From: Huber, Rachelle <RHuber@scsengineers.com>
Sent: Wednesday, September 2, 2026 7:10 PM
To: Nathaniel Dickel
Cc: Kevin Green; Bill Haley; Sarah Phillips; Dylan Smith; Jones, Art; Viswanathan, Srividhya; Sullivan, Pat; Bob Dick; Medina, Steven; Johnson, Cage; Travis Rohde; Baitong Chen; Larry Israel; Christina Ojeda
Subject: RE: Chiquita Canyon Landfill (Facility ID 119219) - Condition 63 Leachate Schematic
Attachments: 2026-09-02_CCLF Tank Farm Site Map(s) As-Built_v0.6.pdf

Please find the attached leachate schematic for your use.

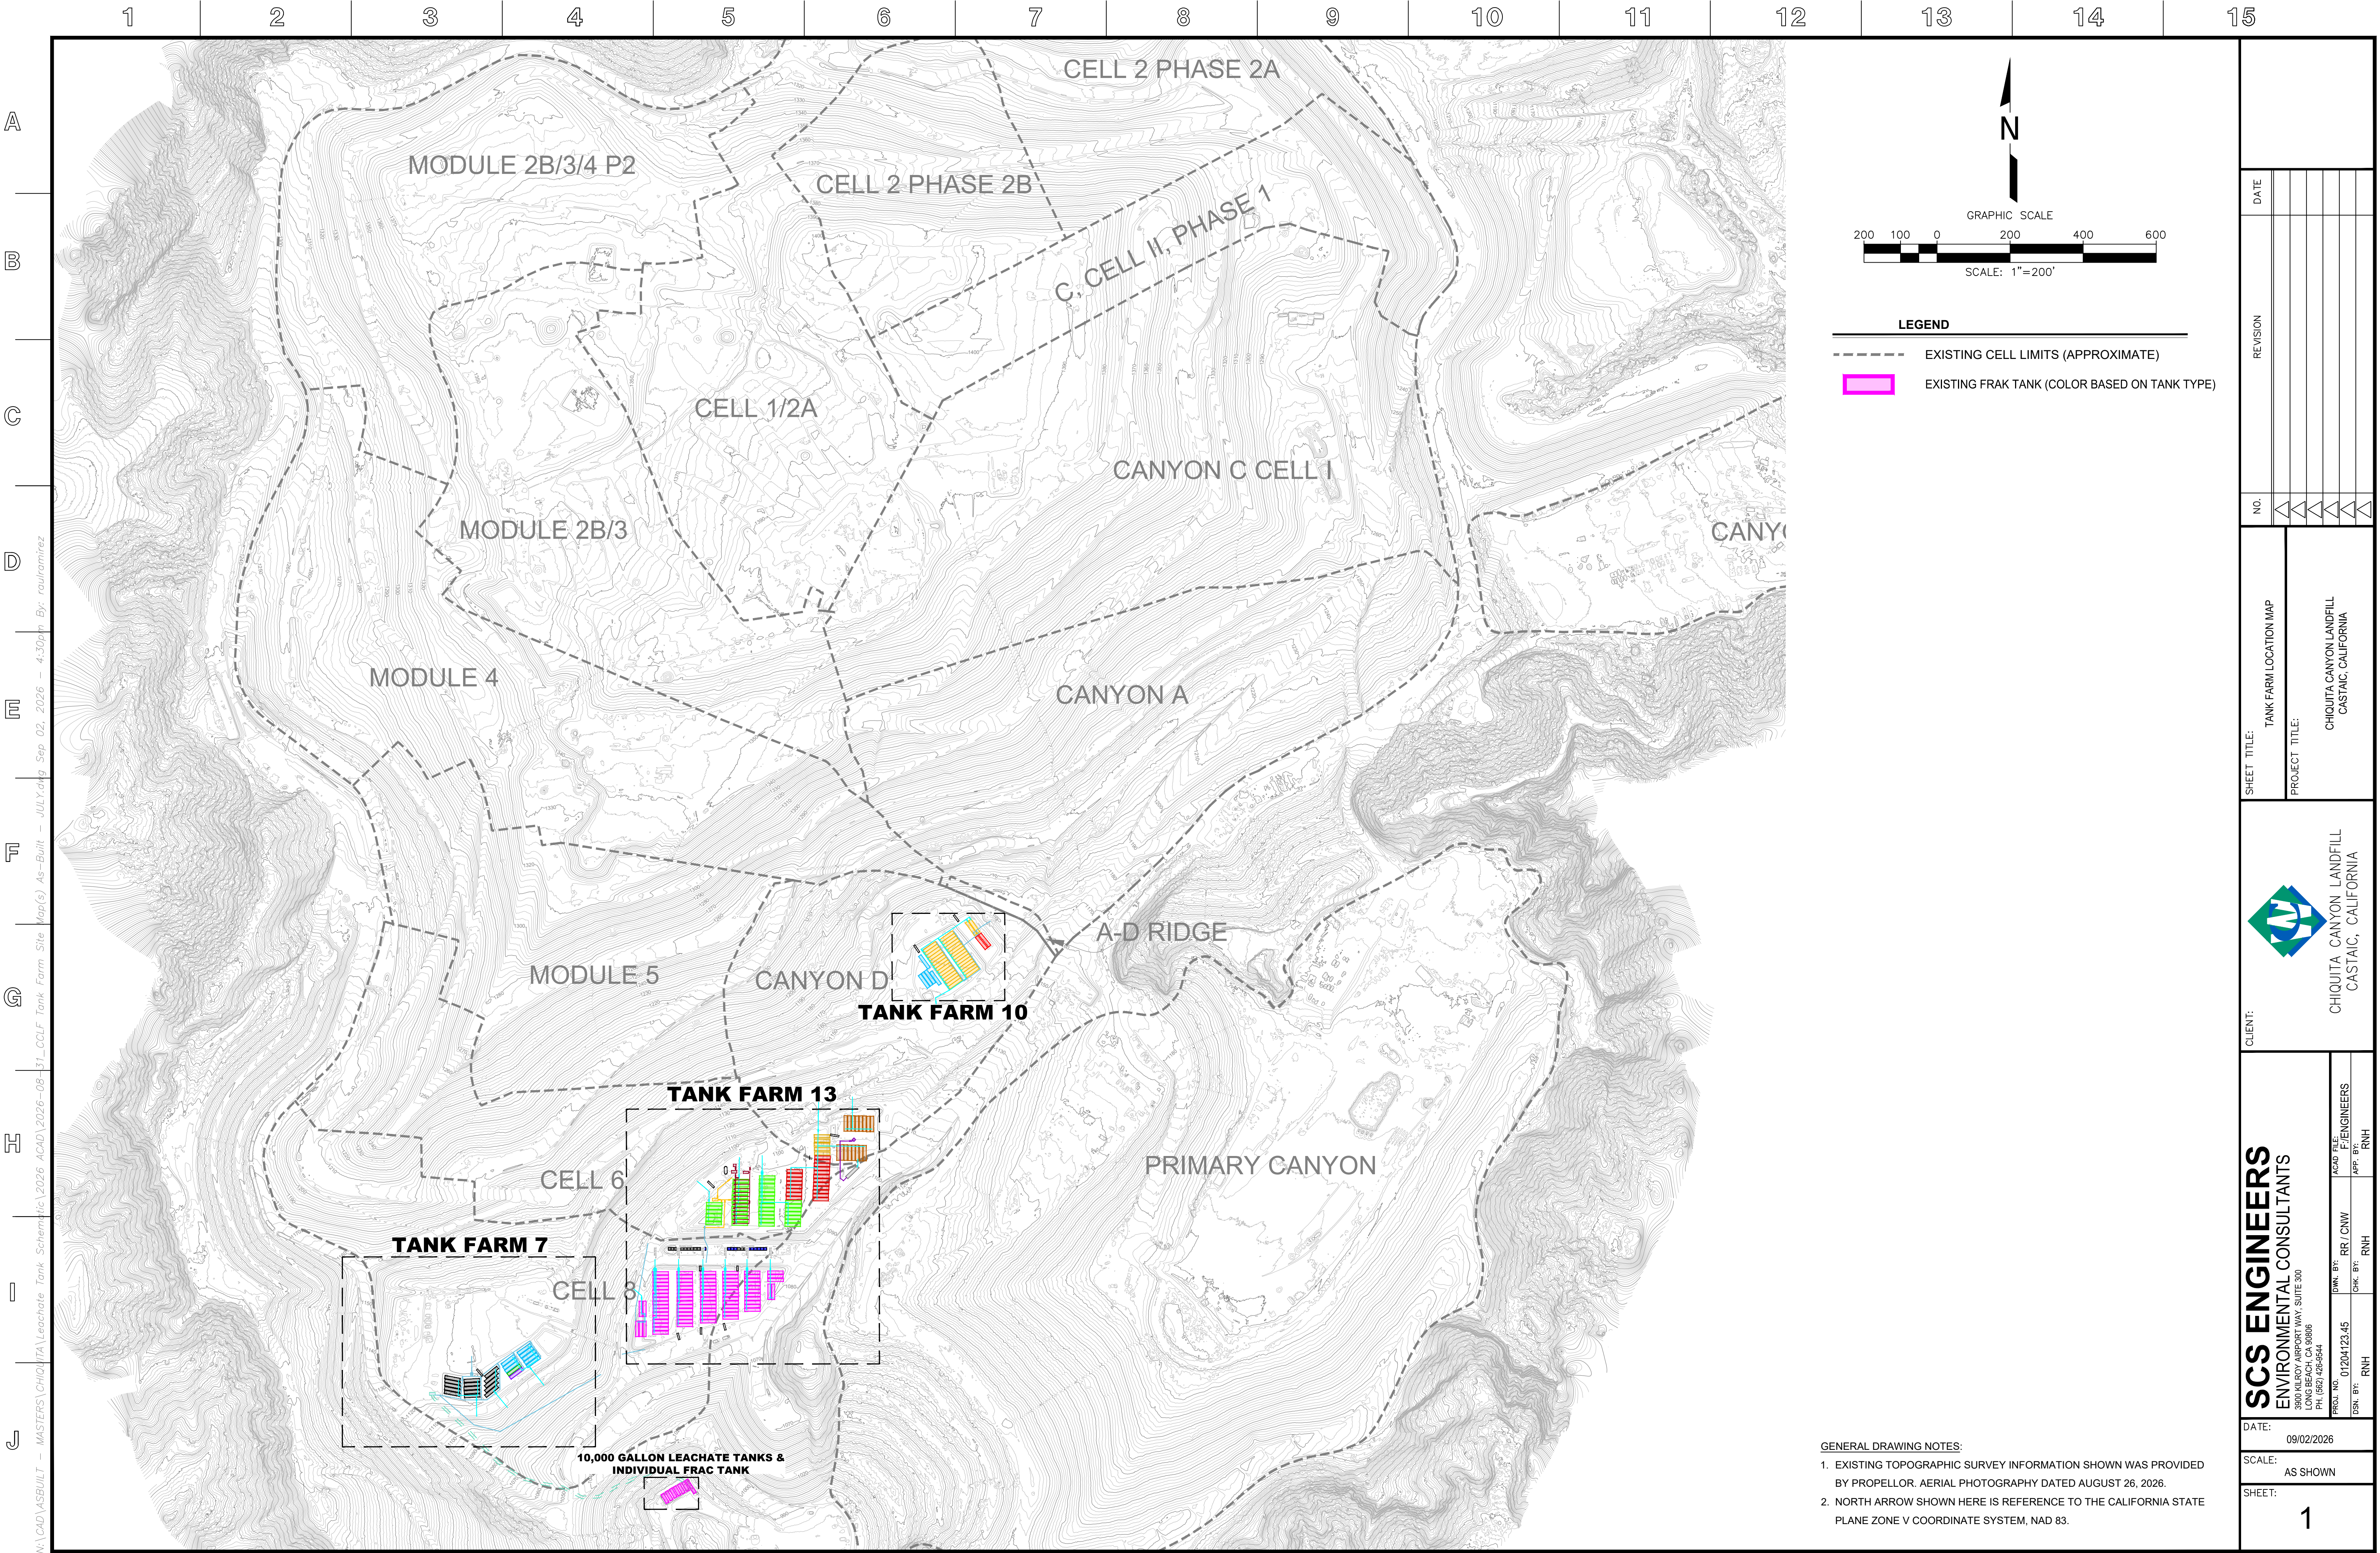
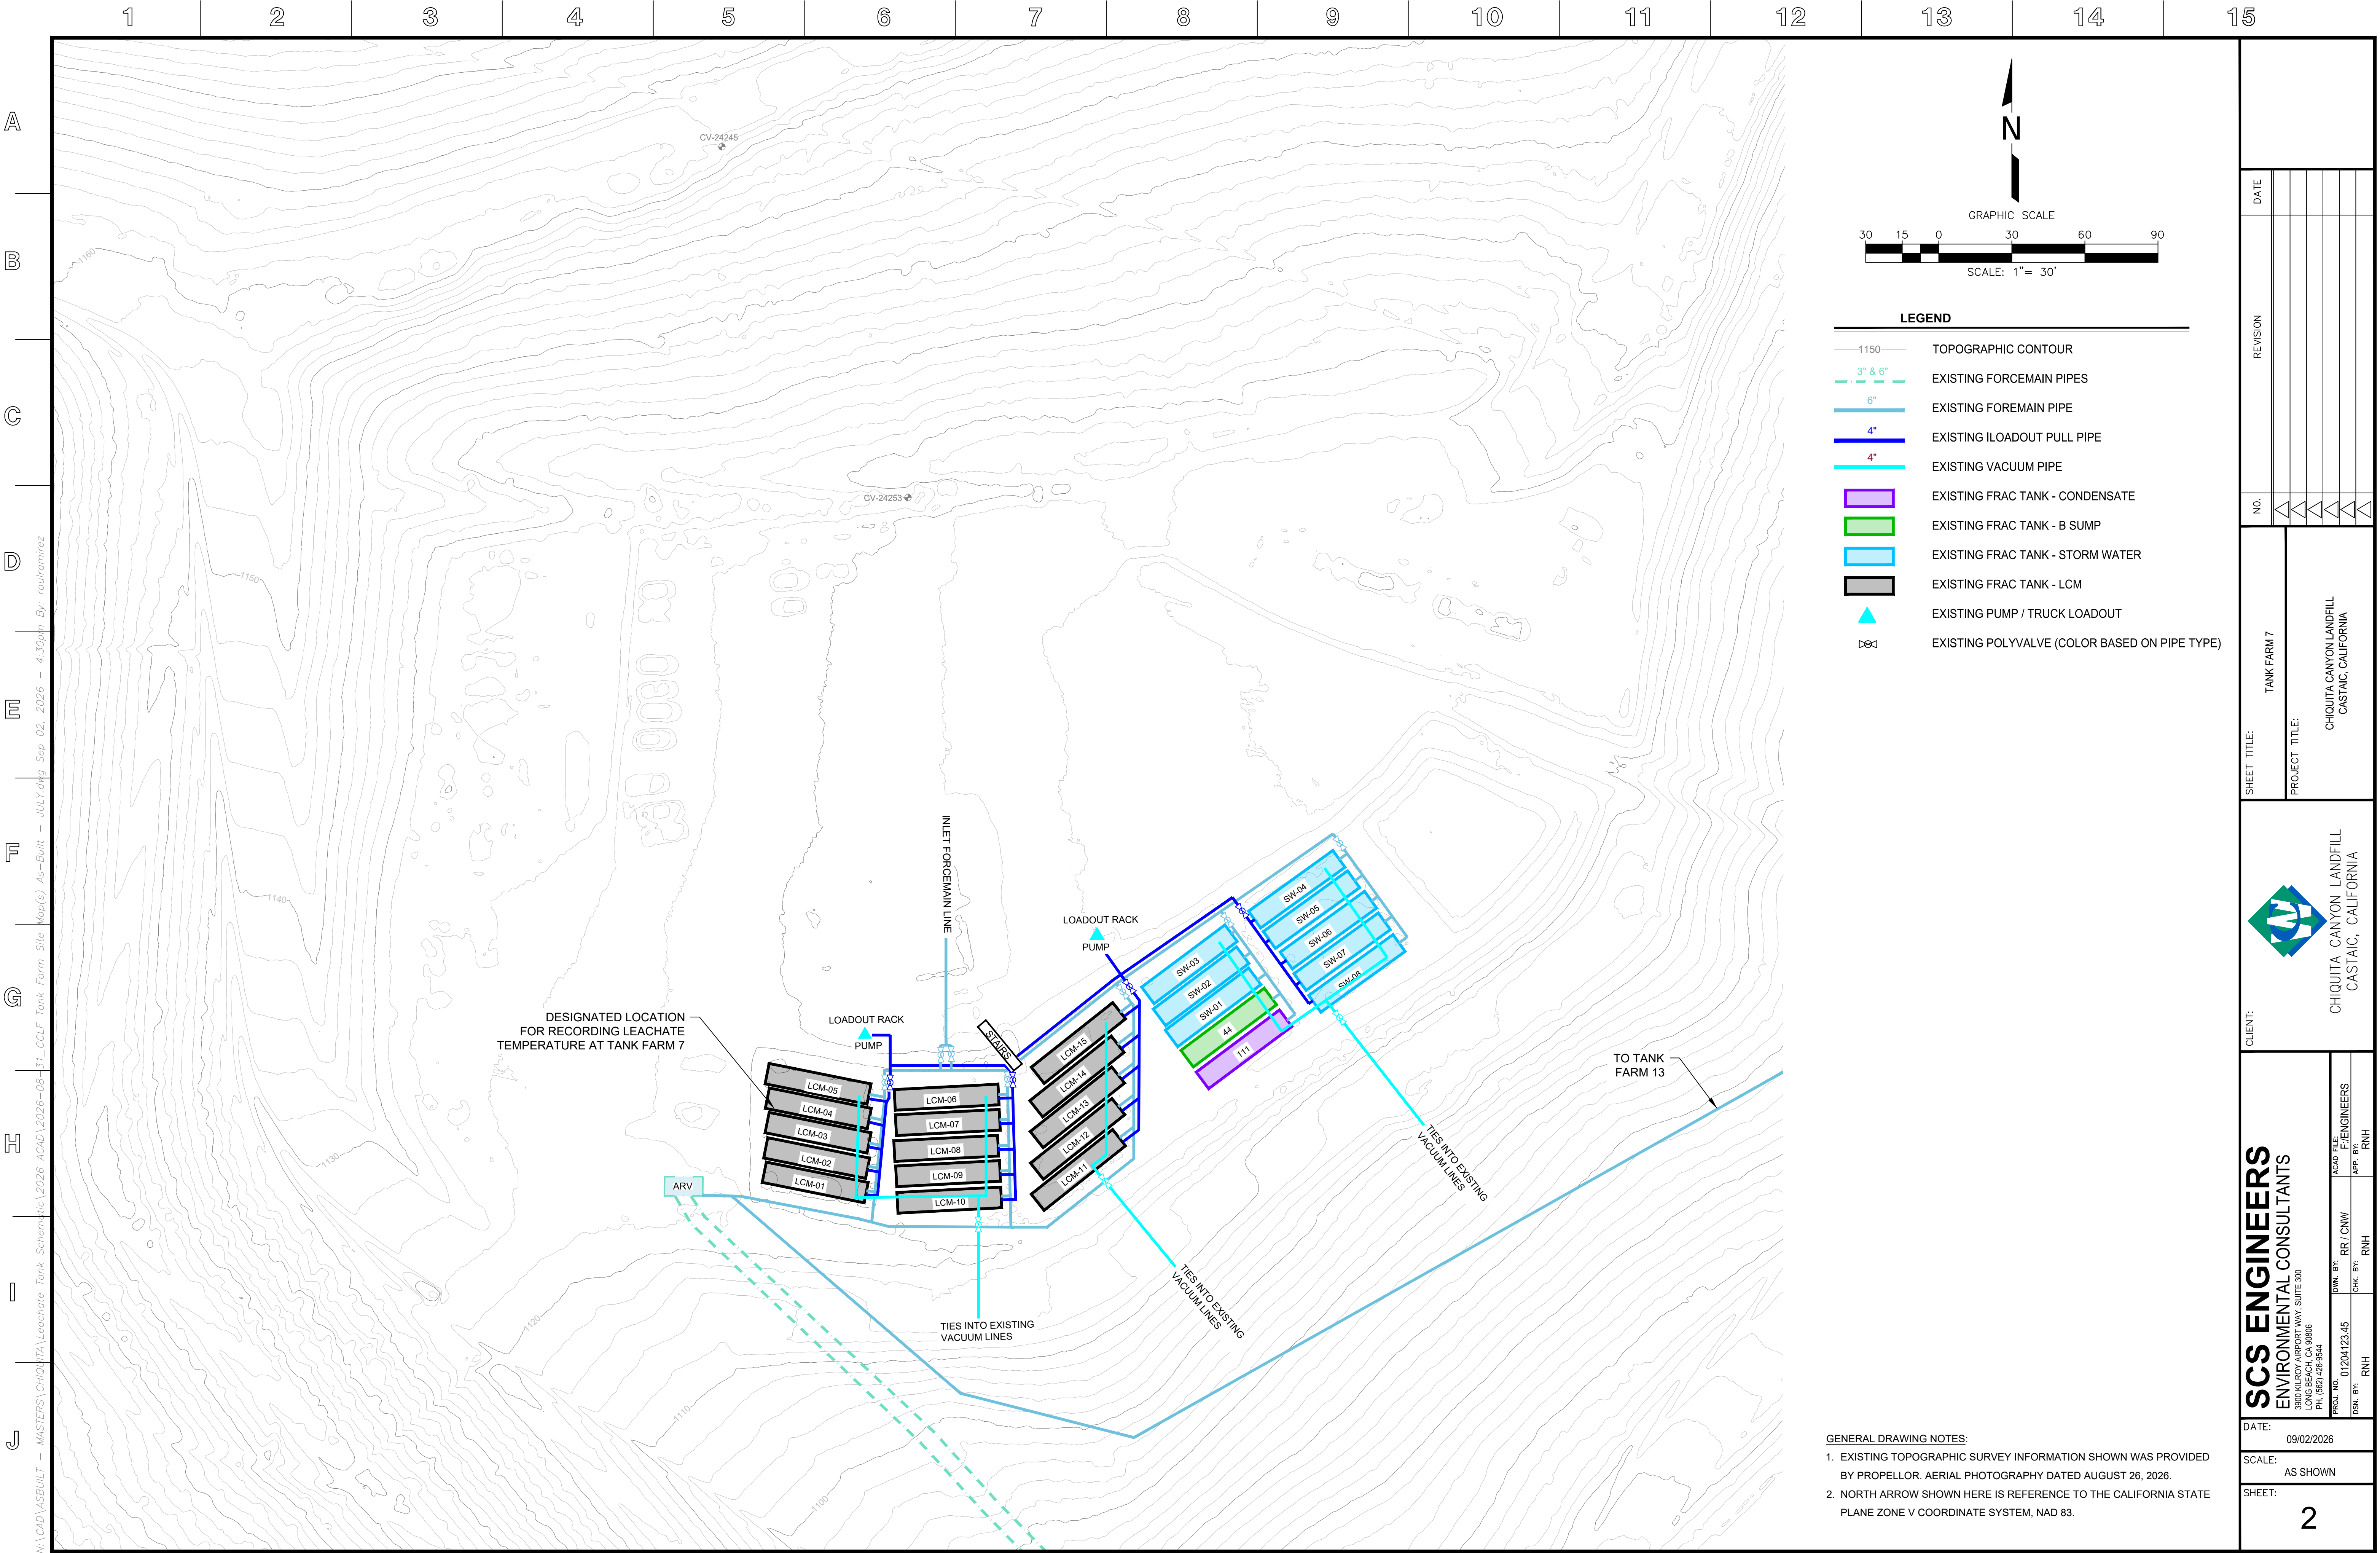
1. Tank Farm 10

- a. The provided as-built schematic does not mention any vacuum vent lines in the associated legend and does not show any vacuum vent lines on the schematic itself. Please confirm these tanks are vented to the gas collection system/control equipment and provide a revised schematic indicating the locations of the vent piping and valves.
 - ***Please find in the attached leachate schematic.***

2. Tank Farm 13 Pre-Treatment

- a. The provided as-built schematic and associated legend indicate there is vacuum piping only on the aeration treatment tanks (U13-13 through U13-18). There may be mislabeling in the legend, and miscoloring of certain piping within the tank farm. The cyan colored piping throughout the schematic is indicated to be drainpipe, inconsistent with the schematics for Tank Farm 7 and Tank Farm 13 Post-Treatment. Please review and provide a revised schematic for the Tank Farm 13 Pre-Treatment tanks.

- ***Please find in the attached leachate schematic.***
- b. Indicate whether tank T1/T2 190 is vented to control equipment, how liquid enters/exits the tank, and update the schematic as necessary with any vacuum and/or liquid piping. The current schematic shows the tank isolated without any connected vacuum piping, liquid piping, or loadout rack/pump.

- ***Condensate from the knockout pot at the flare station is directed through piping to either Tank T1 or Tank T2, both of which are located at the flare station. Condensate enters each tank through piping connected to the bottom of the tank. Each tank is also equipped with a vacuum line connected to the top of the tank that routes tank vapors to the flare station for control.***

- ***When the tank receiving condensate approaches capacity, Chiquita switches the condensate flow to the other tank. The condensate accumulated in the first tank is then removed by tanker truck and transported to Tank 190 in Tank Farm #13. Transfers from Tanks T1 and T2 to Tank 190 occur as needed based on the condensate level in Tank T1 or Tank T2.***

- ***Tank 190 is vented from the top of the tank and is connected to the same vacuum system that extracts vapors from the clarifier tanks at Tank Farm # 13. Condensate is transferred from the tanker truck into Tank 190 via an existing loadout filling***

station pipe through a 4-inch valve located at the bottom of the tank, and liquid exits Tank 190 through the same 4-inch valve at the bottom of the tank. The schematic is updated to show the applicable vacuum system, the existing loadout filling station pipe, and the 4-inch valve on Tank 190.
